## WEST SUSSEX COUNTY COUNCIL - PRE APPLICATION CONSULTATION

| <b>FROM:</b>            | WSCC - Highways Authority                                                                                                         |
| <b>LOCATION:</b>        | Land at Old Wickham Lane Gatesmead Haywards Heath RH16 1SN                                                                        |
| <b>SUBJECT:</b>         | Internal Reference: PRE-77-25<br><br>A development of up to 60 residential dwellings at Land at Old Wickham Lane, Haywards Heath. |

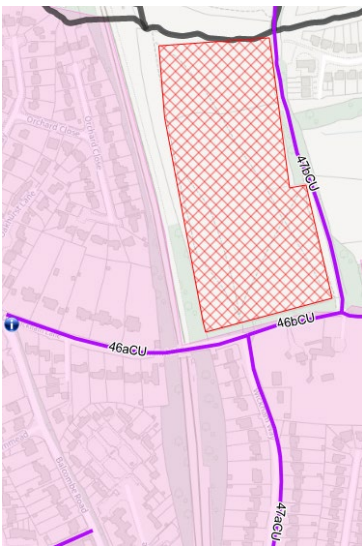
Option 1 (groundworks) would require the road to be built up on top of existing ground and require the PROW to rise to carriageway level then back down. The PROW connection to north would require a steeper slope and it is noted this PROW is a leisure route, not designed for mobility impaired. Option 2 proposes suspending road above existing ground, the PROW will require rising to carriageway level and back down with ramps provided from the bridge deck and potential steps on north side.

1. The options outlined in the report for the PROW route are reasonably sensible, but a decision regarding the composition of the road carrying feature over the RPZ is required before solutions for the PROW route over can be agreed.

2. Option 1 for the mounded earth solution is far more practicable and less challenging than connecting a ramp to a bridge (Option 2). Both are achievable, but road carrying solution should be agreed before selecting the preferred Option 1.

3. Regardless of the PROW route being an earth worked solution or a structural solution, it is recognised that the site is geometrically constrained and therefore a steeper than desirable ramp will be required, and or/steps. I would suggest both if possible.

5. Gradients of 1:12 are considered acceptable for ramps to footbridges, and so also ok for non-structural ramps, but such gradients must be over limited distances and rest landings must be supplied at suitable intervals. Noting that providing any landings will lengthen the overall ramp, providing landings may prove to be impossible without further detrimental effects of either a even steeper route or increased length (which then clashes with the adjacent footbridge). Compromise of the length and / or gradient will be required and would tentatively be accepted given the environment and site constraints.

Summary: A fully compliant route is accepted as being not reasonably practicable to achieve so compromises on some technical requirements can be given. A maximum gradient of 1:12 is broadly considered acceptable but the detailed design of the ramps, connectivity with the road carrying feature, and connectivity of the adjacent PROW features should be subject to further scrutiny and approvals, least of all due to the uncertainty of the composition of the road carrying feature that could significantly impact on what is / is not viable for the PROW approach ramps.

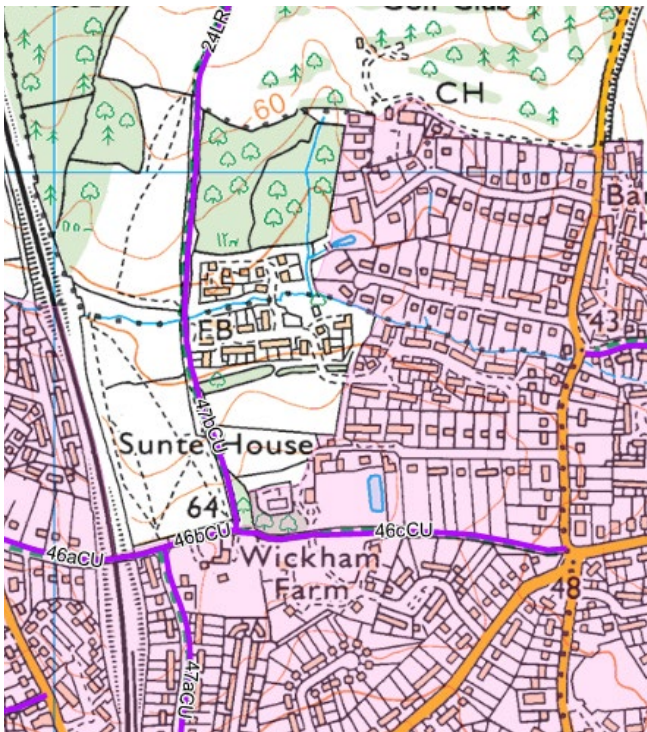
The PROW are incorrectly described (para 3.3.2 of the Transport Scoping Report) and should be as shown below.

The Footpaths affected are FP46aCU, FP46bCu (both along the southern border and forming part of the Sussex Diamond Way) and FP47bCU along the eastern border. All are footpaths and not bridleways as the latter is wrongly described within Appendix A Access Proposals.

The safety of PRoW users is my main concern, where the main access road crosses FP47bCU. I understand there will be a traffic calming feature and a 20mph speed limit. There should be signage warning vehicles of pedestrians crossing.

Access to the proposed development from the (current) cul de sac (Gatesmead) would involve the road crossing PROW Footpath 47bCU and the Review suggests designs to achieve this.

A 1:12 ramp on the north side is acceptable and Option 1 is our preferred option details of the crossing will be addressed on receipt of the full planning application.
